# Access Compliance Report

### (Curb Ramps)

Intersection ID: 7129	Main Street: DAWNSHIRE_AV	Cross Street: NORTHBROOK_DR	Location: NW
ADA ID: 9E2E92D0F602	Ramp Type: Perp	Initial Pass/Fail: Fail	Overall Compliance: No
Severity Score: 1.25			
Codes/Mitigation Info/Possible Solution		Field Measurements/Component Compliance

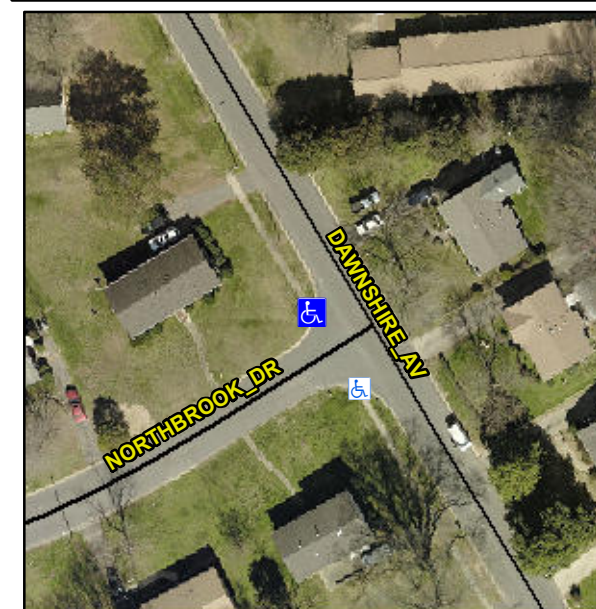
**Not Found, R304.5.3**

Compliance	Description	Data	Compliance	Description	Data
N/A	Ramp Length (in)	41.0	Yes	Ramp Slope (%)	5.5
Yes	Ramp Width (in)	48.0	No	Ramp XSlope (%)	4.1
N/A	Flare Type LT	N/A	N/A	Flare Type RT	N/A
N/A	Flare Slope LT (%)	N/A	N/A	Flare Slope RT (%)	N/A
N/A	Flare Traversable LT?	N/A	N/A	Flare Traversable RT?	N/A
N/A	Landing Length (in)	N/A	N/A	DWS Provided?	N/A
N/A	Landing Width (in)	N/A	N/A	DWS Contrast?	N/A
N/A	Landing Slope (%)	N/A	N/A	DWS Length (in)	N/A
N/A	Landing X Slope (%)	N/A	N/A	DWS Full Width?	N/A
N/A	Landing Curb? (Y/N)	N/A	N/A	DWS Offset (in)	N/A
N/A	Shared Landing?	N/A			
N/A	Gutter Ponding?	N/A	N/A	Gutter Slope (%)	N/A
N/A	Gutter Lip Ht (in)	N/A	N/A	Gutter X Slope (%)	N/A
N/A	Painted X Walk1?	No	N/A	Painted X Walk2?	N/A
	X Walk 1 Direction	To SE		X Walk 2 Direction	N/A
N/A	X Walk 1 Width (in)	N/A	N/A	X Walk 2 Width (in)	N/A
	X Walk 1 Slope (%)	1.6		X Walk 2 Slope (%)	N/A
	X Walk 1 X Slope (%)	3.8		X Walk 2 X Slope (%)	N/A

**Remove & Replace Entire Ramp.**
